ESHID-603647

Subject: Response to Administratively Incomplete Determination Part A and General Part B of the Resource Conservation and Recovery Act (RCRA) Permit Renewal Application Los Alamos National Laboratory EPA ID#NM0890010515, HWB-LANL-20-001

**Response to Administratively Incomplete
Determination Part A and General Part B of the
RCRA Permit Renewal Application Los Alamos
National Laboratory EPA ID#NM0890010515,
HWB-LANL-20-001**

Attachment 2
Maps of Groundwater Contamination Plumes at LANL

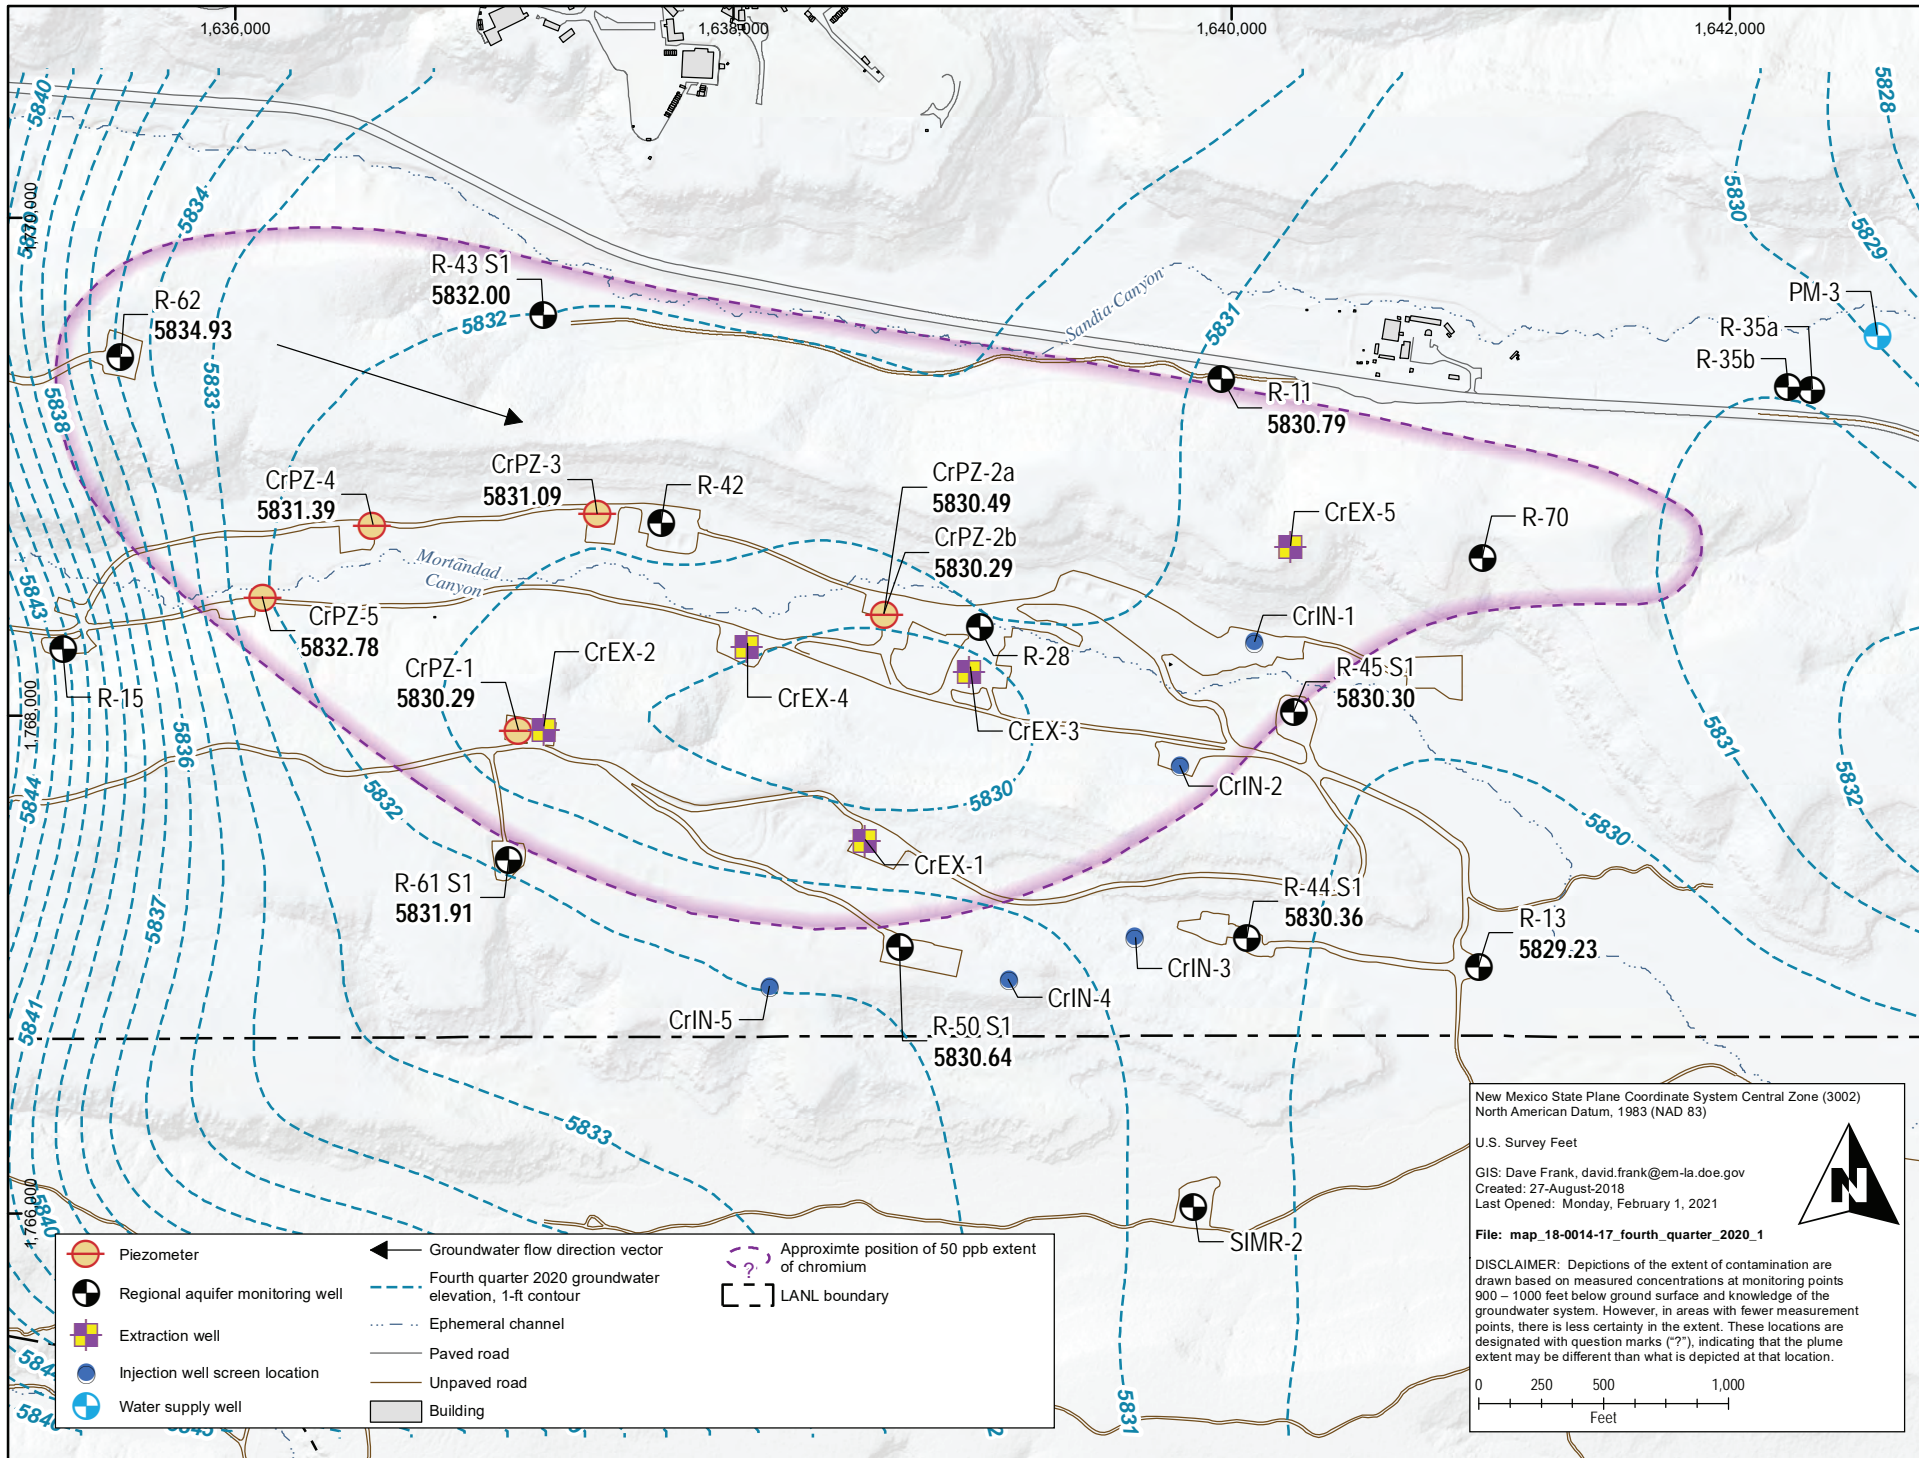
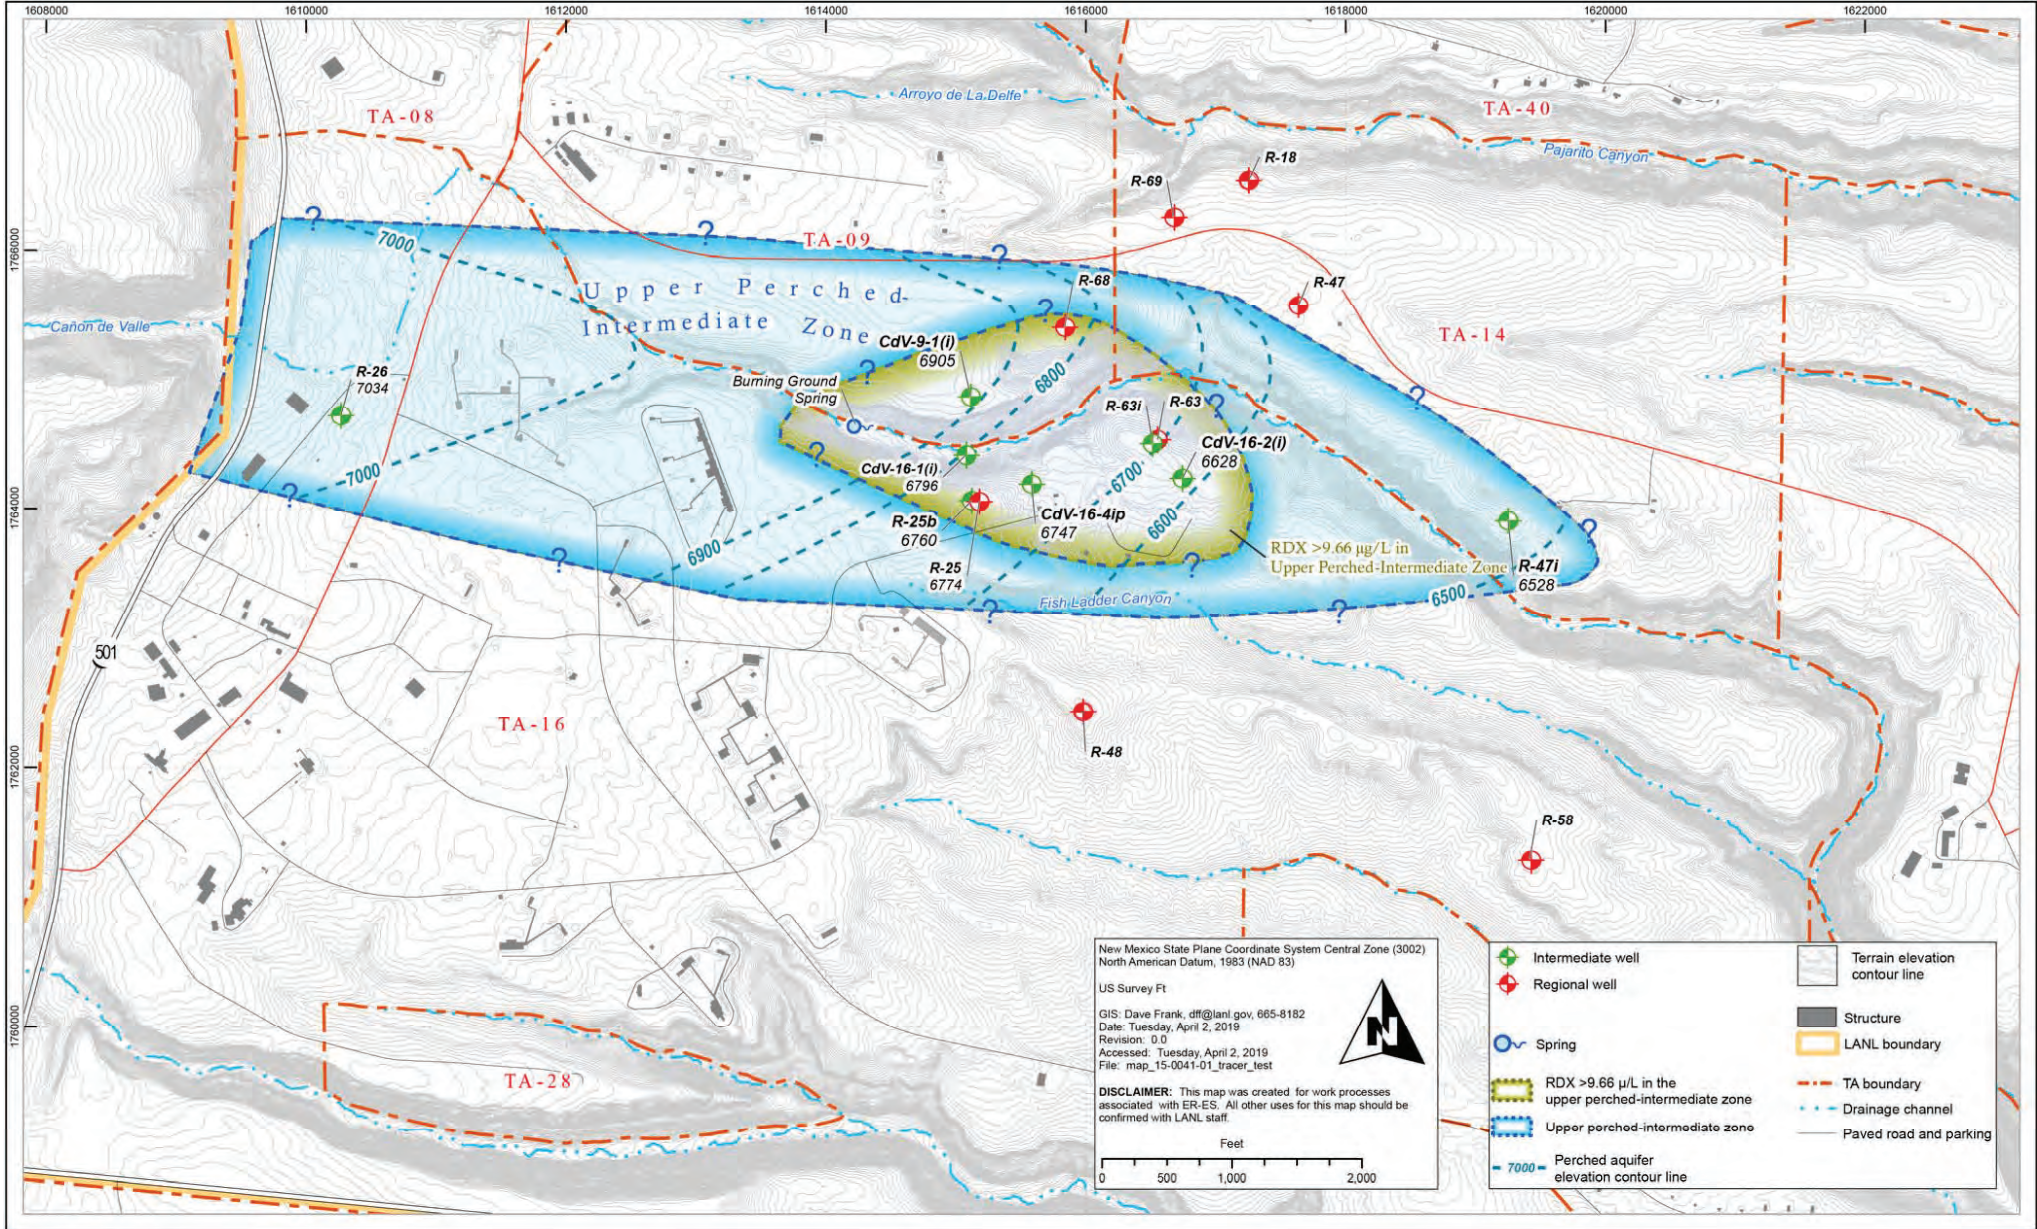
The United States Department of Energy (DOE), Newport Nuclear-BWXT (N3B), and Triad National Security, LLC. (Triad), collectively the Permittees, have not provided maps depicting the extent of the existing ground water plumes at the LANL Facility (Facility, as defined in 40 CFR 260.10) in accordance with the above requirements. Maps 2 and 3 show National Pollution Discharge Elimination System (NPDES) site locations and other groundwater monitoring wells, however, these maps do not provide contaminant plume boundaries. Include maps depicting extent of plumes and maximum concentration of contaminants on a topographic map as required by 40 CFR 270.14(b)(19).

There is no evidence of groundwater contamination associated with the regulated units at LANL; therefore, a map of groundwater contamination plumes is not included within the Permit and was not included within the Permit Renewal Application. As described in Permit Renewal Application Section 2.16, *Groundwater Monitoring*, groundwater at LANL is monitored under the 2016 Consent Order by the LANL Interim Facility-Wide Groundwater Monitoring Plan. There are no changes proposed to Permit Section 11.3.1, *Groundwater Monitoring* presented in the Permit Renewal Application Section 2.16. All known groundwater plumes are from SWMUs/AOCs, and are addressed under the Consent Order. As a courtesy, the most recent published plume maps for chromium and RDX are attached to this response (Attachment 2). These plume maps have already been provided in the *Quarterly Report for the Discharge of Treated Groundwater to the Regional Aquifer under Discharge Permit 1835, Calendar Year 2020 Quarter 4*, submitted to NMED-HWB February 26, 2021, and *Investigation Report for Royal Demolition Explosive in Deep Groundwater*, submitted to NMED-HWB on August 29, 2019, located in the N3B electronic reading room, <https://ext.em-la.doe.gov/epr/readingroom.aspx?room=2>. It should be noted that concentration/plume maps will change based upon data results.
